Subject: Duke Energy Carolinas, LLC
William States Lee III Nuclear Station – Docket Nos. 52-018 and 52-019
AP1000 Combined License Application for the
William States Lee III Nuclear Station Units 1 and 2
Supplemental Partial Response to Request for Additional Information
(RAI No. 6182)
Ltr# WLG2012.03-04

- 1) Lee Nuclear Station Supplemental Partial Response to Request for Additional Information (RAI), Letter No. 100, RAI 03.07.02-001

Lee Nuclear Station Supplemental Partial Response to Request for Additional Information (RAI)

Lee Nuclear Station
Attachment 1 to Supplemental Response to
Request for Additional Information 03.07.02-001,
Westinghouse Electric Company Report
WLG-1000-S2R-803, Revision 0
William S. Lee Site Specific Seismic Evaluation Report

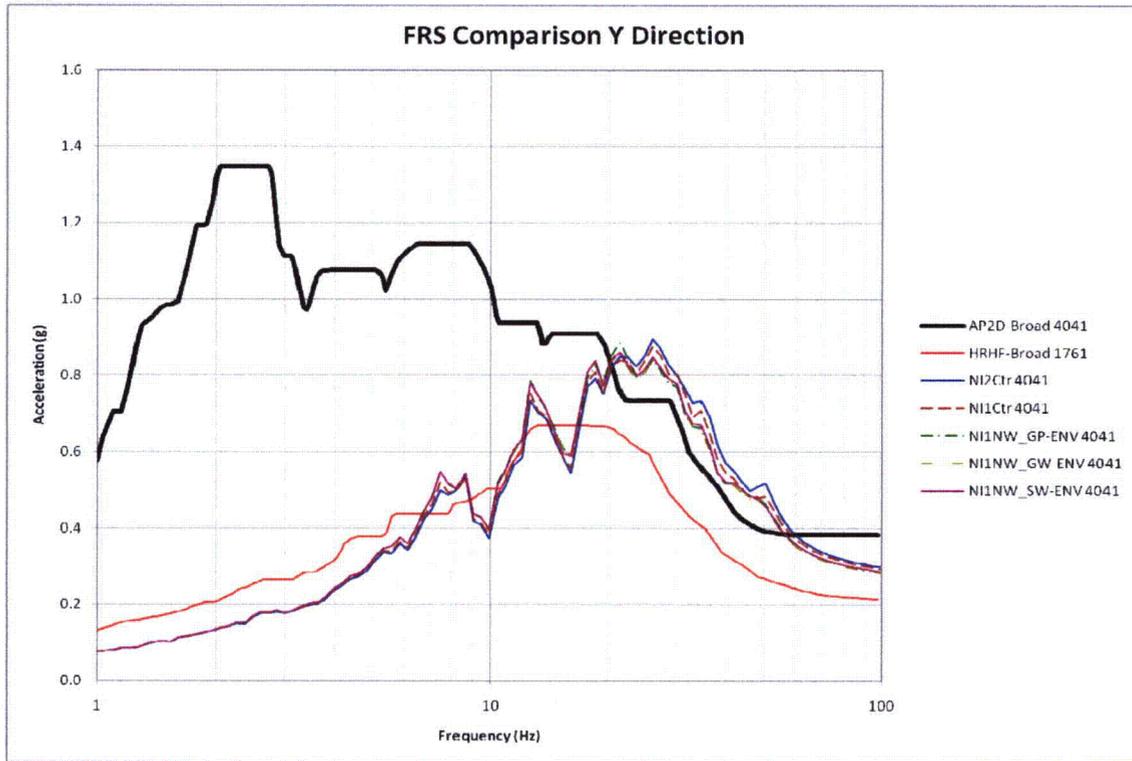
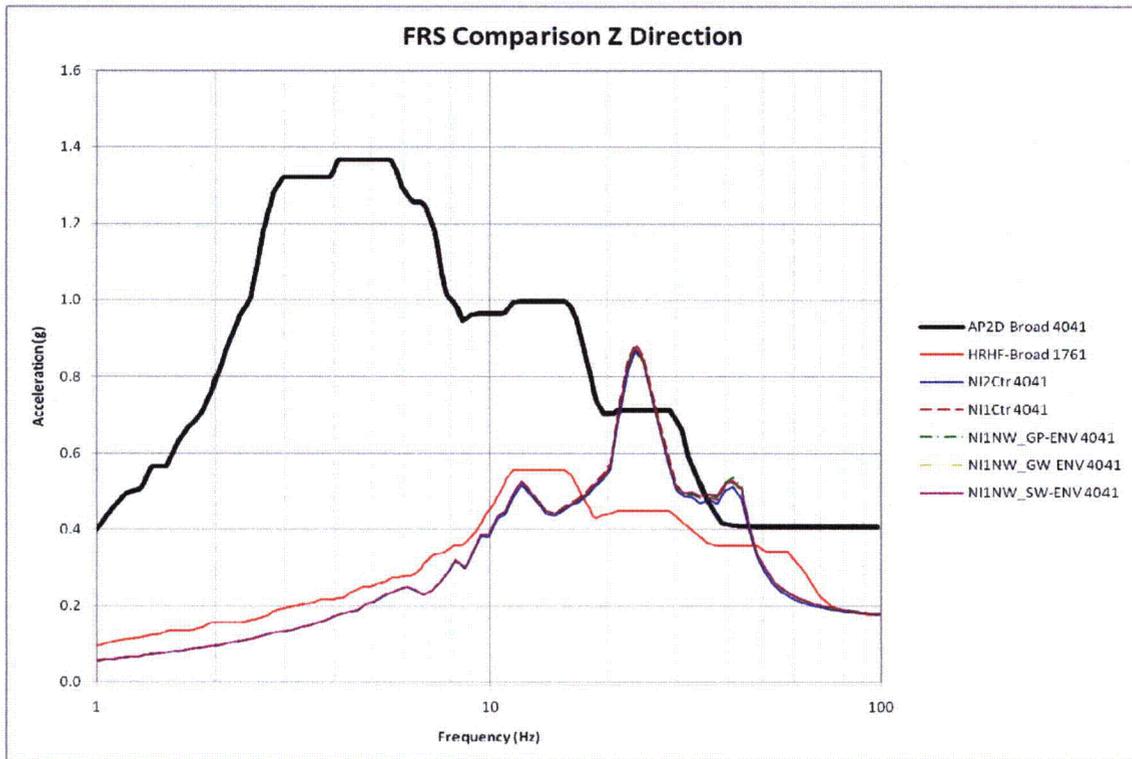
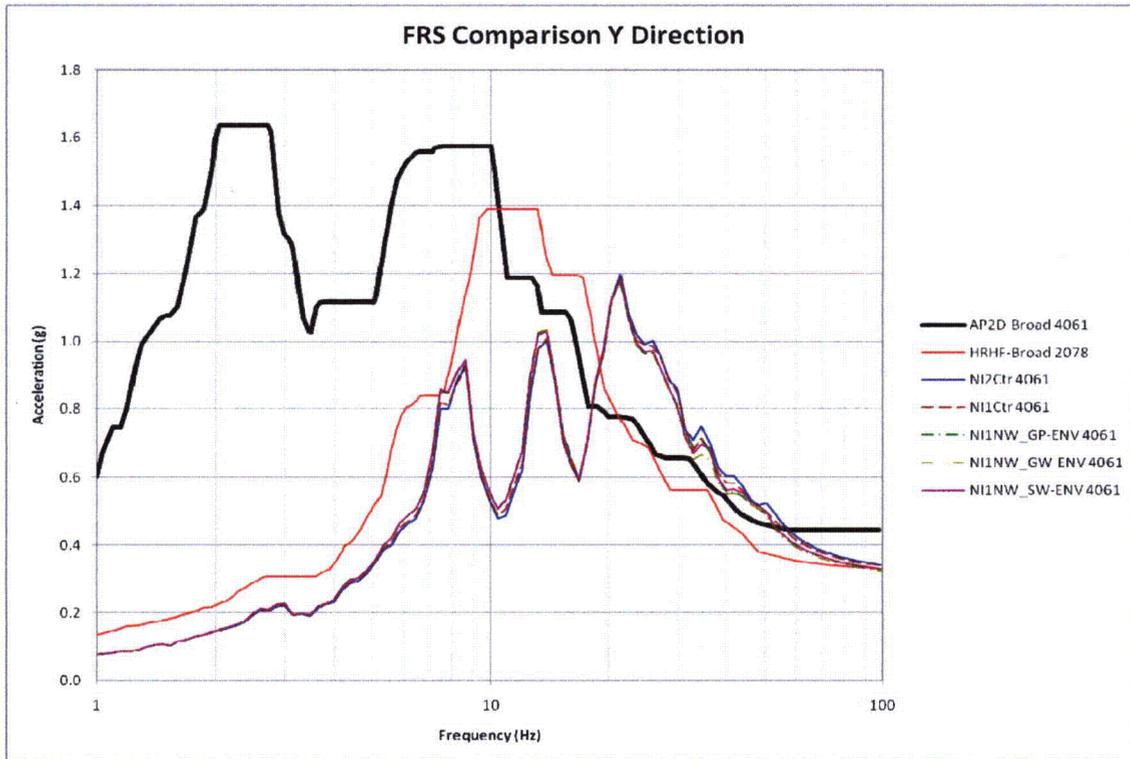
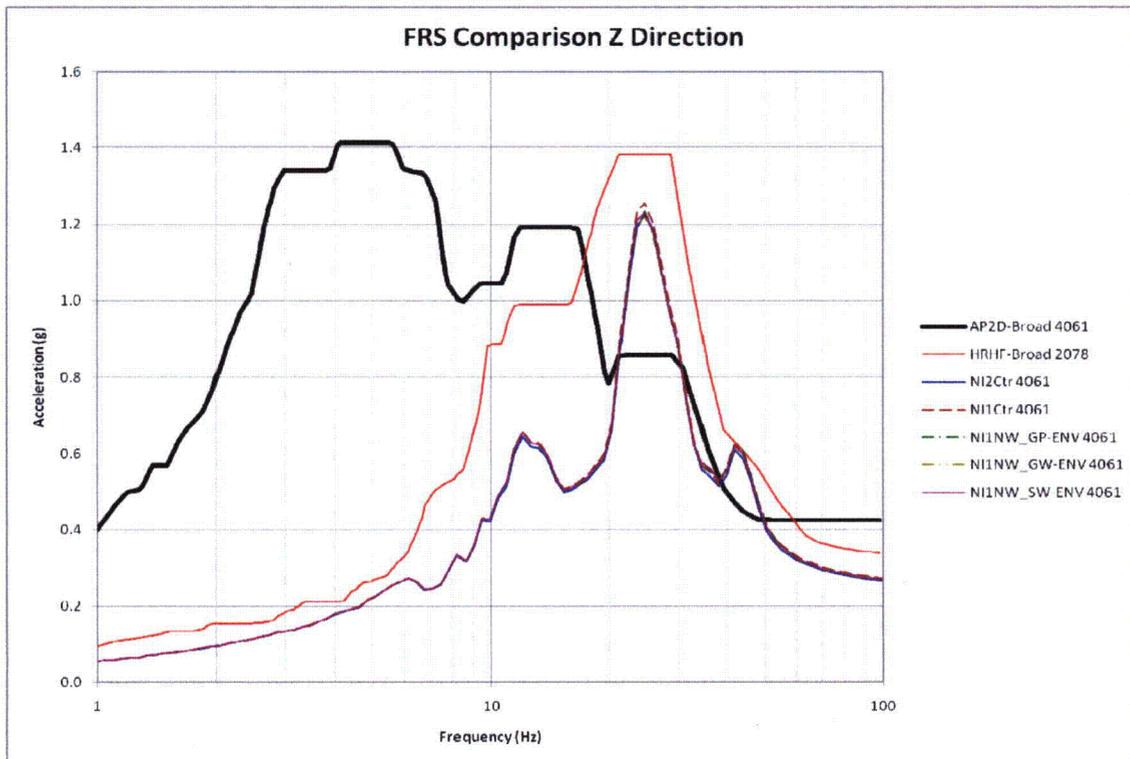
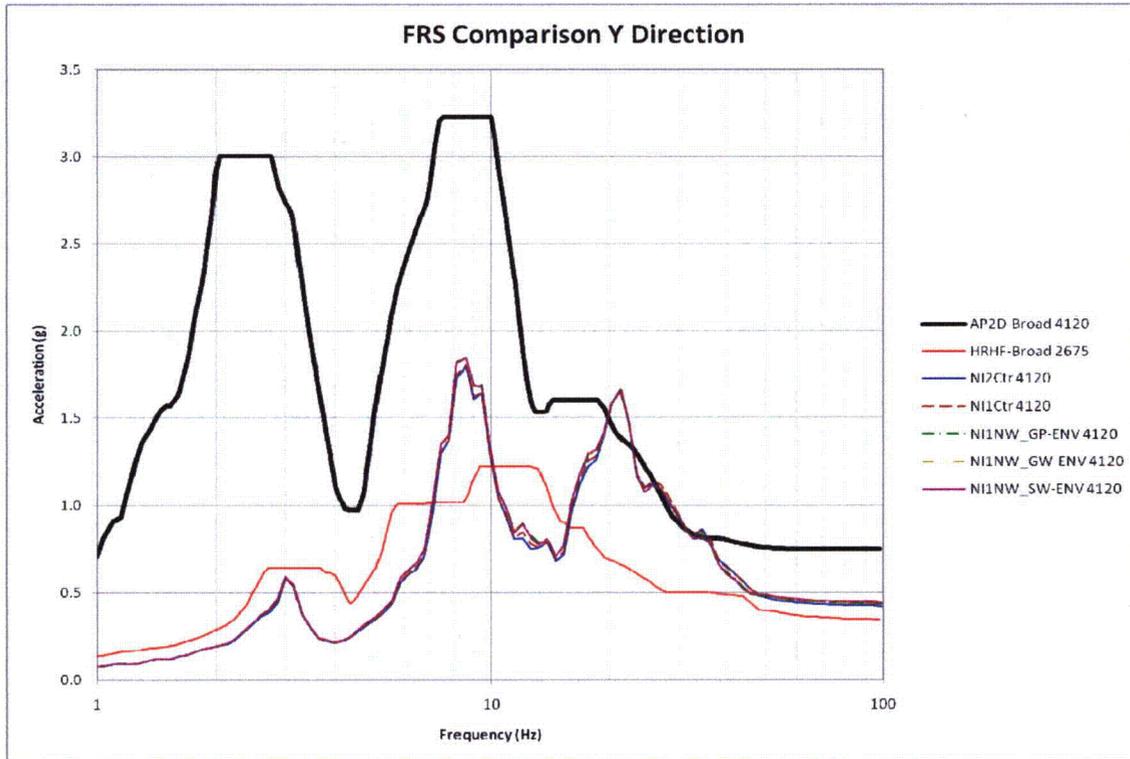
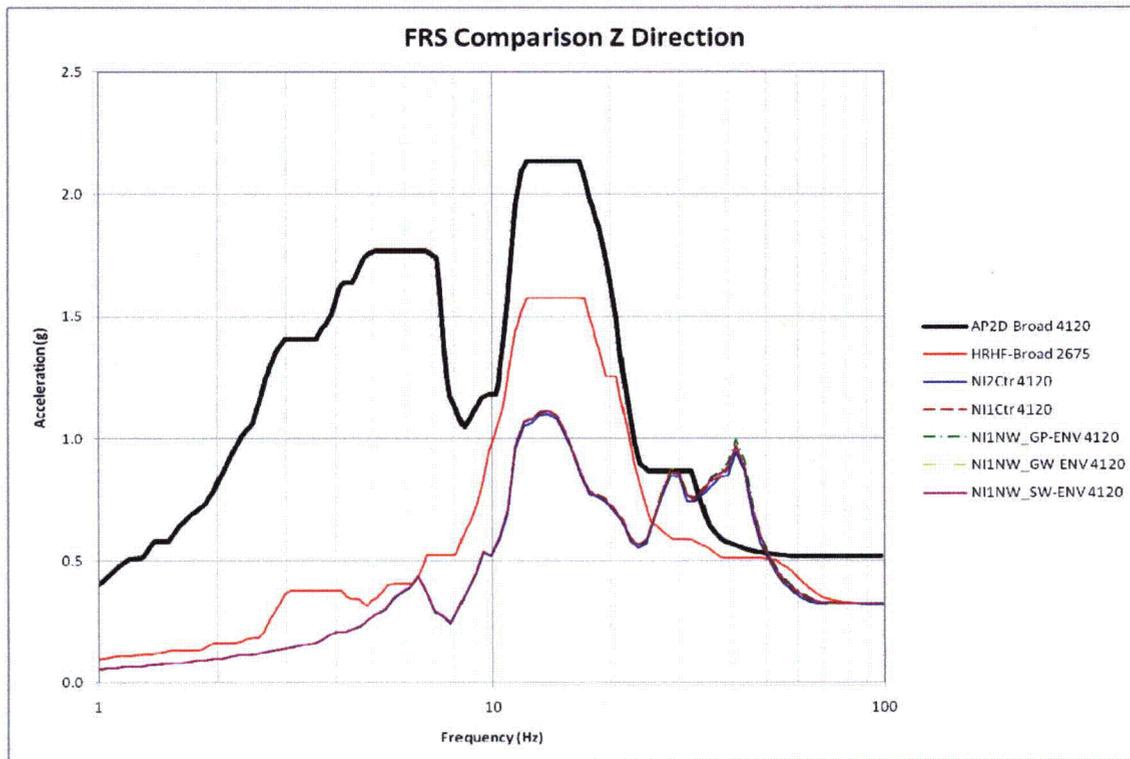
Staff review of the applicant's sensitivity study finds that the assessment of the NW corner effects should include a comparison of vertical responses (Figures 6-1 through 6-6), since a "soft" corner may affect the rocking response of the nuclear island. In addition, staff notes that AP1000 DCD Section 2.5.2 states that, for site-specific analysis of hard-rock sites, the COL applicant should compare in-structure response spectra (ISRS) to the AP1000 HRHF spectra at the locations given in APP-GW-GLR-115, "AP1000 Standard Combined License Technical Report Effect of High Frequency Seismic Content on SSCs." Since Appendix A does not contain such comparisons, the staff requests the applicant to provide comparisons at locations described in APP-GW-GLR-115, Section 5.2. In order to assess the significance of the sensitivity study results on the standard design, the applicant is requested to provide comparisons

of the sensitivity study results to the standard plant design spectra (HRHF and CSDRS). If the Unit 1 seismic demands (including vertical response) exceed those of Unit 2, the applicant should justify the use of the Unit 2 profile (centerline) for the 3D SSI analysis of Unit 1.

In response to item (b), Section 5 of Attachment 1 presents site-specific horizontal and vertical in-structure floor response spectra (FRS) that result from two-dimensional east-west analyses of the nuclear island. Three cases are considered: the Unit 1 centerline founded on a profile of fill concrete over hard rock; the Unit 2 centerline founded on a hard rock profile; and a Unit 1 Northwest corner model that includes a range of granular fill material placed beside the nuclear island and below the level of the nuclear island basemat. In-structure FRS are presented at the six key locations identified in DCD Subsection 3.7.2 and DCD Table 3G.4-1, similar to the locations investigated in Section 5.2 of APP-GW-GLR-115. The resulting 2D east-west horizontal and vertical spectra are compared to the corresponding in-structure FRS from DCD-supporting analyses using the CSDRS and HRHF spectra.
